SALT WASTE PROCESSING FACILITY INDEPENDENT TECHNICAL REVIEW

November 22, 2006

SPD-SWPF-217

Figure 4-1. Dose Rate with Concrete Shielding for 86 Ci/gal Infinite Source

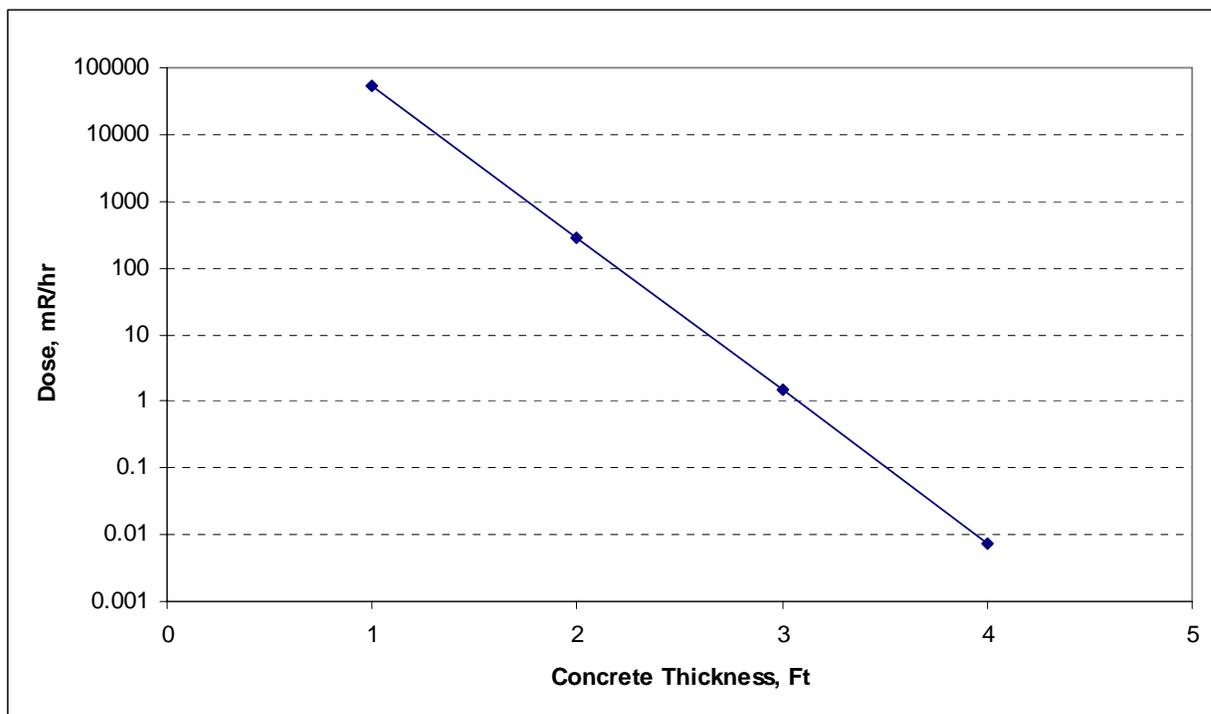
- An independent, simplified scoping calculation was conducted by the reviewer to gain perspective on the shielding thickness needed for cesium sources of the magnitude anticipated within the SWPF. This was done by modeling a disk source of water that is 10 ft thick with a 50 ft radius to simulate a planar field imposed upon a concrete wall. The concentration used was 86 Ci per gallon, which is the safety basis maximum concentration. The resulting dose rate along the axis on contact with the concrete shield is shown in the following graph (Figure 4-1). This indicates that, in general, a concrete wall thickness of 3 to 4 ft will result in a dose rates less than 0.5 mR/hr. This leads to the conclusion that the bulk wall thickness in the SWPF design is sufficient.

The EPC shielding calculations results in dose rate predictions that are conservatively high; that is, in some cases they can create a need for more shielding than is necessary. This may not matter with regard to the design as bulk shielding thickness is not usually “fine-tuned” to dose calculations as long as it is sufficient.

Figure 5-1. Basic Hierarchy of Design Criteria and Specifications

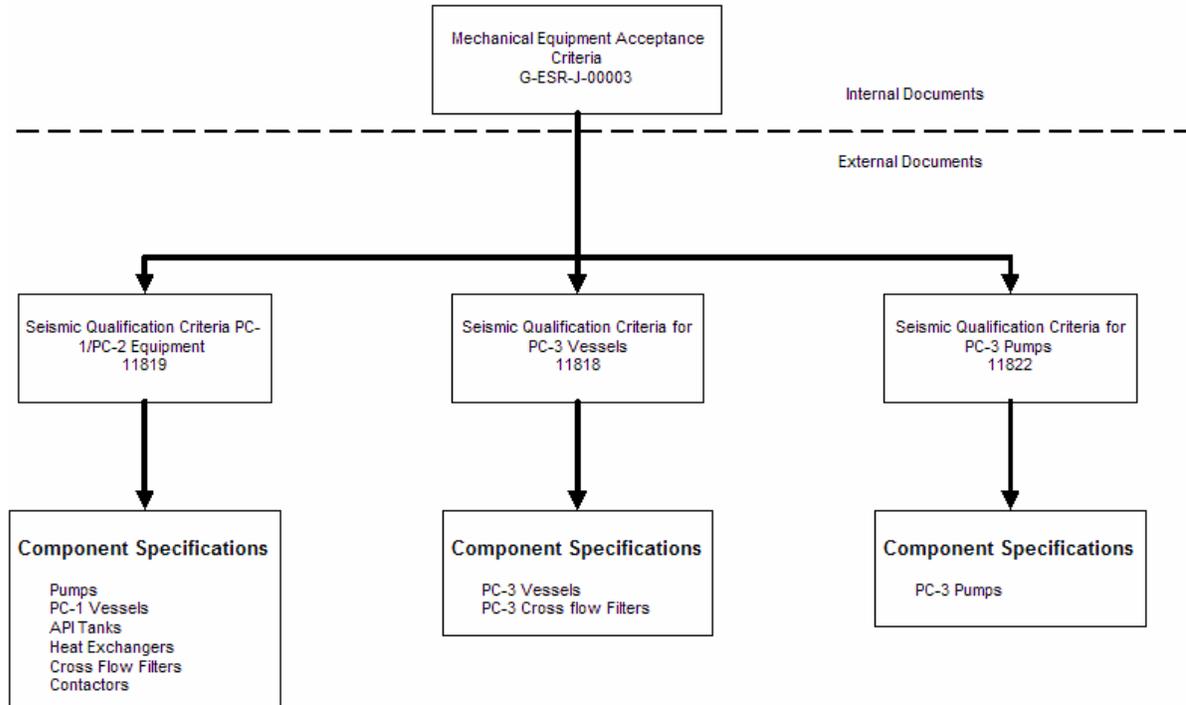
Figure 5-1 provides the hierarchy of design criteria and specifications being used by EPC for Mechanical Equipment. There is a general internal Mechanical Equipment acceptance criteria document (G-ESR-J-00003^[35]) and also various individual specifications that will be sent to the vendors. All these specifications were reviewed in depth; the ITR found that the criteria put forth in each specification are correct and consistent with the SWPF design basis. However, the specifications are inconsistent in format, guidance, and detail. In addition, there is a lack of concise definition of the load combinations to be used, the stresses to be

Recommendation AC 5.2-31: The ITR recommends that the mechanical equipment qualification specifications should be reviewed and updated for consistency, conciseness, and to provide more definitive guidance to the vendors. Figure 5-2 shows the type of information that would be suggested for an ASME Pressure Vessel specification.^[36] A similar format and information would be suggested for other components.
